NP-11-0040
September 1, 2011

Subject: Exelon Nuclear Texas Holdings, LLC
Victoria County Station Early Site Permit Application
Response to Request for Additional Information Letter No. 06
NRC Docket No. 52-042

RAI 02.04.04-1:**Question:**

Figure 2.4.4-17 Finish Grading East of the Power Block and Location where Eastern Breach Begins

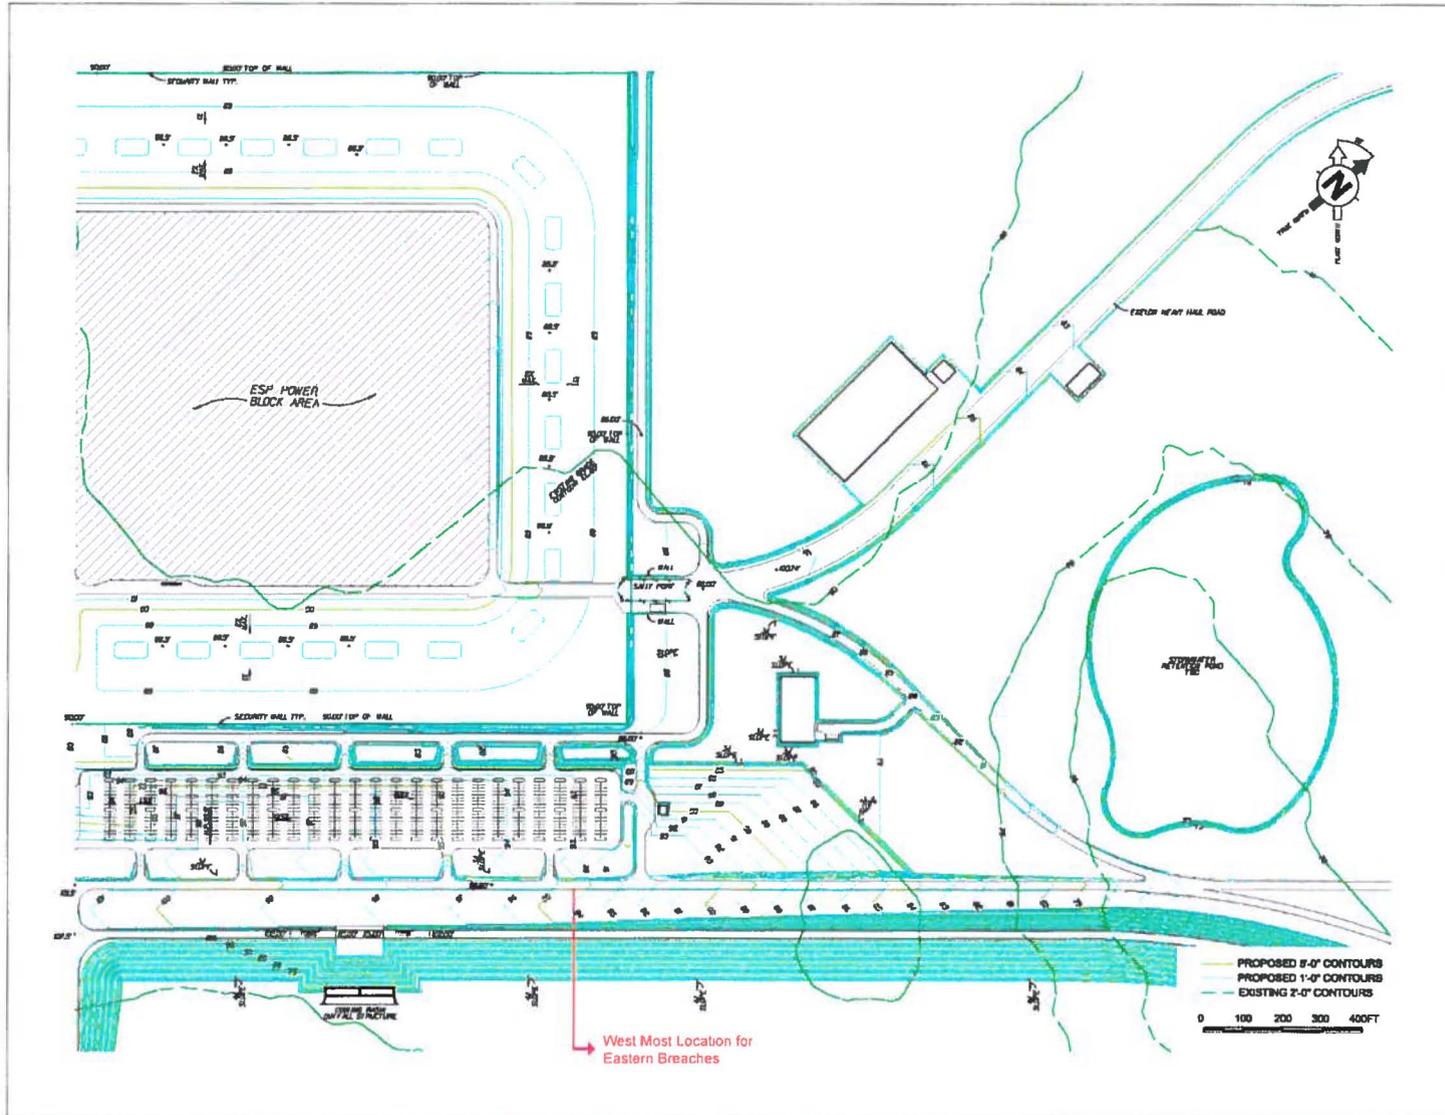
The staff has reviewed the application in accordance with the requirements of “Factors to be considered when evaluating sites” 10 CFR 100.20(c), and “Contents of application: technical information in the final safety analysis report” 10 CFR 52.79(a). The staff has reviewed FSAR Section 2.4.4, Potential Dam Failures and the dam breach outflow hydrographs for the postulated breach of the cooling basin. The outflow hydrographs are too short to determine if wave runup will impact the site and there is no discussion of the basis for selection of the breach location. Please describe the justification for breach locations and wave runup conclusions and provide a complete outflow recession curve.

As shown in SSAR Figures 2.4.4-16 and 2.4.4-17, the distance between the northern embankment of the cooling basin and the security wall is over 500 feet. The area in between is built up (with fill materials) to elevations in the general range of 86 to 102 feet NAVD 88, from the natural grade of about 80 feet (24.4 meters) NAVD 88. A local drainage ditch south of the security wall has invert elevations slightly lower than 86 feet (26.2 meters) NAVD 88. Specifically:

- Along the mid-section, the grade is filled to 102 feet (31.1 meters) NAVD 88 immediately north of the embankment, decreasing to about 92 feet (28.0 meters) NAVD 88 at 400 feet away at the northern edge of the parking lot, before the drainage ditch and the security wall. The grade elevation gradually decreases towards the east and west from the mid-section.
- Along the western end of the security wall, the grade elevation is approximately 94 feet (28.6 meters) NAVD 88 immediately north of the embankment, dropping to 93 feet (28.3 meters) NAVD 88 at 400 feet away to the north.
- Similarly, along the eastern end of the security wall, the grade is filled to 93 feet (28.3 meters) NAVD 88 immediately north of the embankment, and to 92 feet (28.0 meters) NAVD 88 at 400 feet away to the north.

As described above, most of this built-up area is higher than or has similar elevation to the initial cooling basin level of 93.9 feet (28.6 meters) NAVD 88 for the postulated embankment breaches. It is therefore highly unlikely that the cooling basin will breach through the large amount of fill materials placed between the cooling basin and the security wall. Further towards the east and west, the grade elevations continue to decrease gradually, and the probability that a breach might occur increases slightly. Conservatively, the breach analysis in SSAR 2.4.4 postulates that the embankment would fail where the grade elevation immediately to the north of the embankment is below elevation 96.0 feet (29.3 meters) NAVD 88 on the west and 94.0 feet (28.7 meters) NAVD 88 on the east as shown in the revised SSAR Figures 2.4.4-16 and 2.4.4-17 (attached), respectively.

SSAR Subsection 2.4.4 will be modified to include the above discussion and revisions to SSAR Figures 2.4.4-16, 2.4.4-17, 2.4.4-23 and 2.4.4-26. The figures include details on breach locations. Figure 2.4.4-21 will be revised to make the water level scale consistent with the other figures.
